CITY OF DOVER

PLANNING TECHNICAL REVIEW COMMITTEE –AGENDA

PLAN SNAPSHOT REPORT SITE-2025-0003 FOR CITY OF DOVER, N.H.

Description: Construct 5 story mixed use structure, with commercial space on the 1st floor, along with an ADU, and nine (9) residential units above to include a nine (9) space parking lot.

CS2702

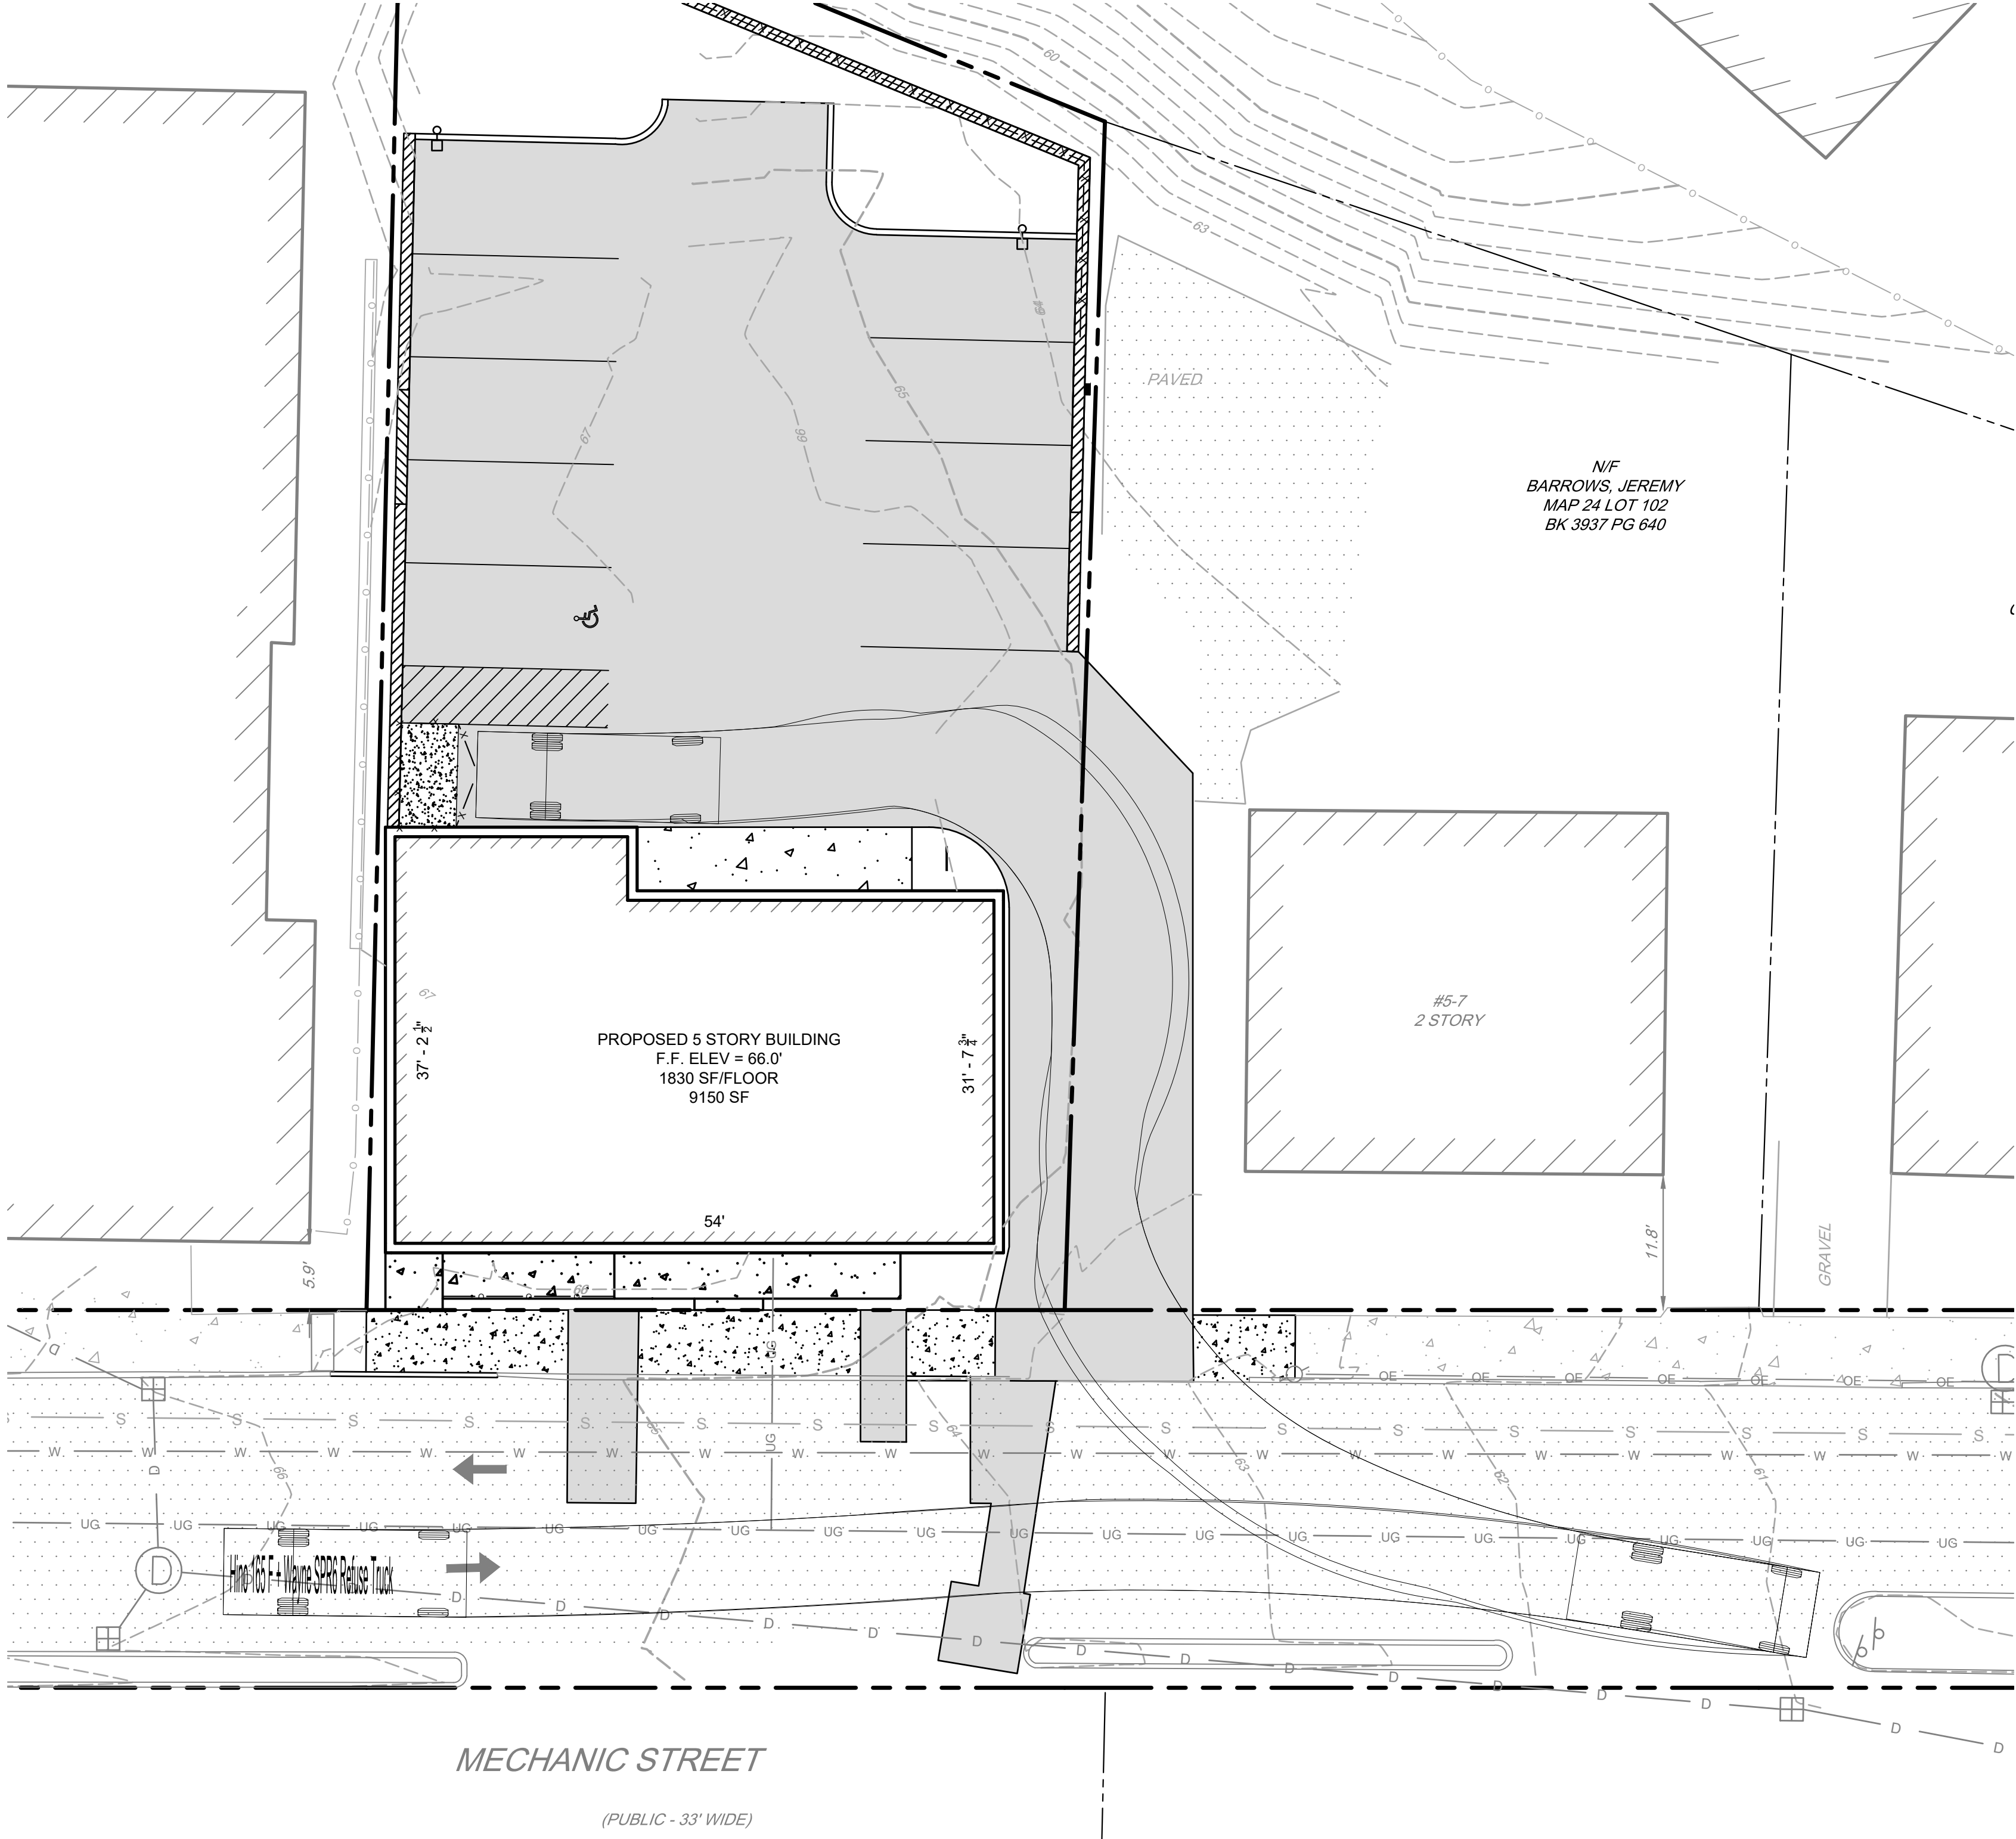
- Turning plan – passenger car turning radius conflicts with curb.
- Utility plan details – water service detail does not match sizes and routing shown on utility plan.

- Include no parking, fire lane signs.
- Ensure FDC in front of building.
- Revise fire truck turnaround to include Dover ladder truck.

3 OUTLET CONTROL STRUCTURE (OC-1)

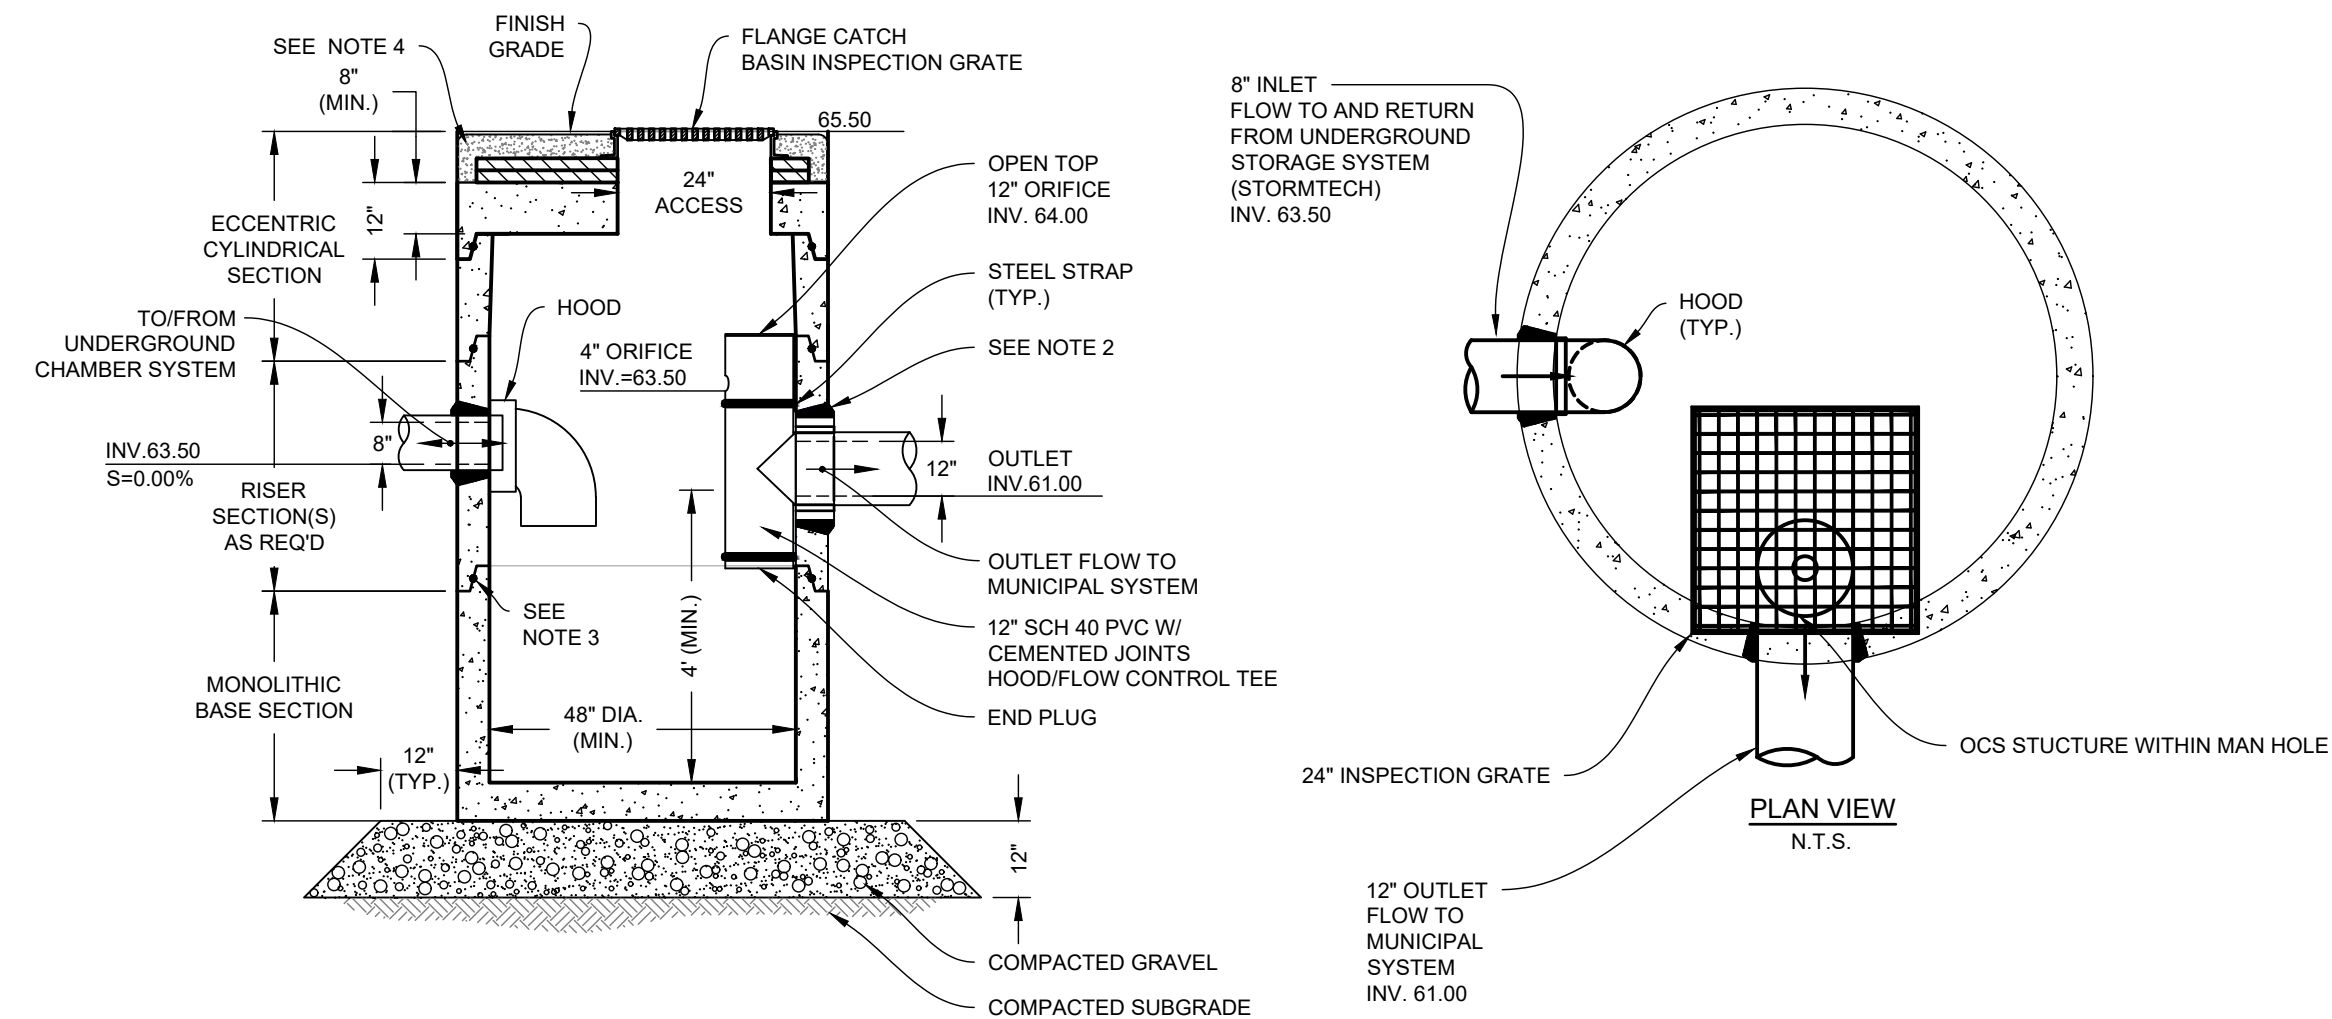
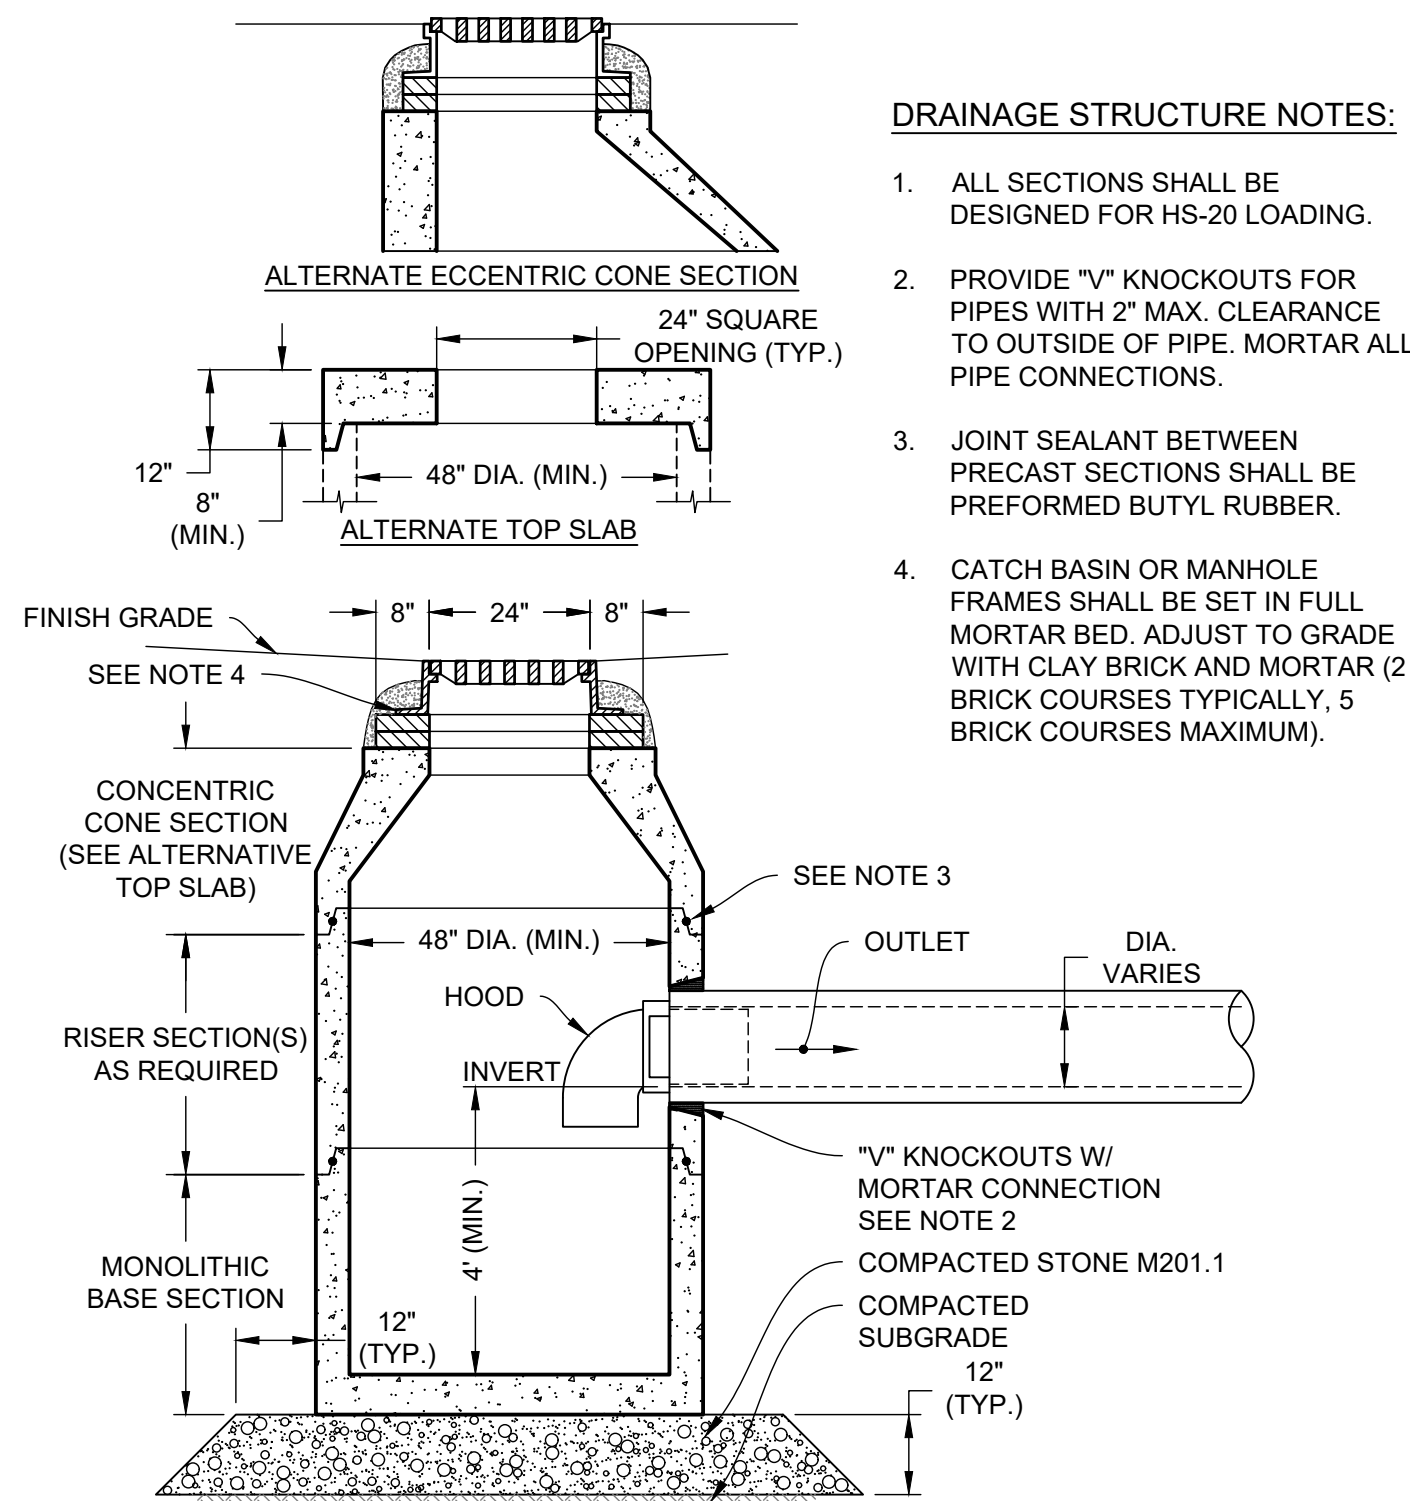
- Minimum cover for drainage pipe shall be 3' per Dover Construction Guidelines.
- Detail calls out Stormtech system. Design does not appear to be Stormtech system.

- What is the design intent of 40 mil barrier in proposed BMP? Not shown in cross section.
- BMP pipe diameters are not clear in drawing and notes.

- No flush curb per City of Dover Details
 - Use City of Dover Details for concrete sidewalk minimums
- Sheet 9 of 11 Drainage Details CS6011
 - Outlet structure rim is set 3" above top elevation of berm

- **The city detail has been added to the plan.**
- Sheet 9 of 11 Drainage Details CS6011
 - Outlet structure rim is set 3" above top elevation of berm
 - **The outlet rim has been revised.**
